Date: **April 28, 2026**
Project: **Tuluksak Power Plant Upgrade Project**
Solicitation No.: **ITB 26070**
Addendum No.: **1**

This Addendum is issued to provide responses to questions received for the referenced solicitation. The questions and answers are included herein, and additional supporting documents are provided as Attachments A through D.

2 NEW GEN#4 EXHAUST WALL THIMBLE OPENING MODIFICATION
M3.1 NO SCALE

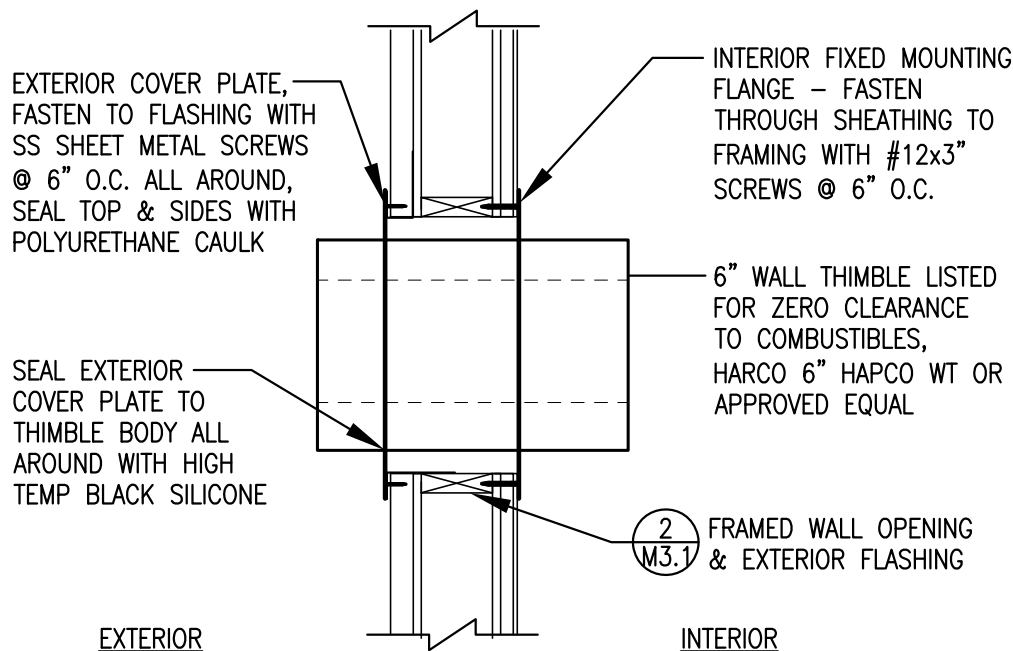
Answer: On pages 355–371 the footer is correct. The header should read 26 32 13.
- 2. Question:** Specific note 2 on sheet M2.1 calls for the existing 5” exhaust thimble at position #4 to remain. Sheet M6 refers to an existing 6” thimble. Does the existing 5” thimble need to be replaced with a new 6”?

Answer: The existing thimble is 5” and it needs to be replaced with a new 6” thimble. Demolish existing 5” thimble and provide a new 6” triple wall insulated wall thimble listed for zero clearance to combustibles, Harco WT or approved equal. Provide framing and flashing as required. See Attachment A for installation details.

3 NEW GEN#4 EXHAUST WALL THIMBLE INSTALLATION
M3.1 NO SCALE

Attachment C Tuluksak E-Gen Temporary Connection to Grid

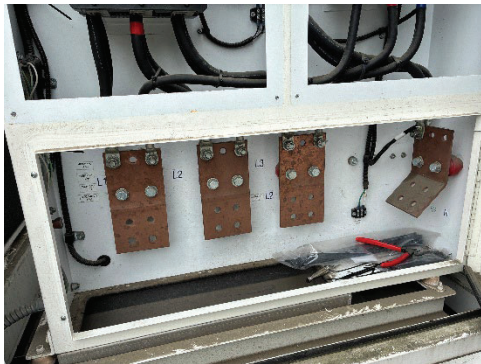
9. Question: What is the hour run time between oil changes? What is est. capacity of oil?

Answer: The scope of work is clarified to make the Contractor responsible for connecting the E-Gen to the grid and to make the utility responsible for operating the EGen. Note 3 on Sheet M1.4 and Note 3 on Sheet E1.2 are hereby replaced with the following Note 3:

C) FURNISH AND INSTALL ALL MATERIALS REQUIRED TO CONNECT THE E-GEN TO THE POWER GRID AS INDICATED ON ATTACHMENT C.

- 1) Drive a 3/4"x10' copper clad ground rod adjacent to the generator and bond to the generator ground lug or frame with minimum #2/0 copper.
- 2) Route 4 each minimum 300A rated conductors in temporary raceway from 480V bus bars in generator up pole and connect to step up secondary.

Attachment D Tuluksak Existing Gen#1 & Gen#2 Photos

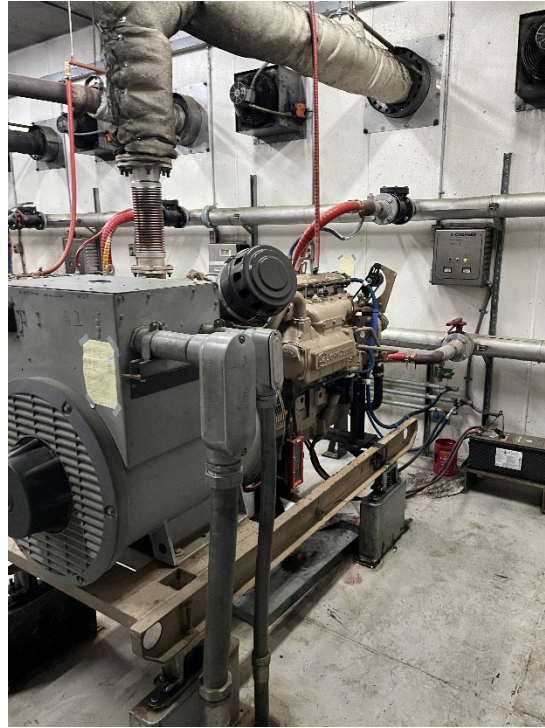
12. Question: Can you provide us with pictures of the installed generators?

Answer: See Attachment D for representative photos of Gen #1 and #2.
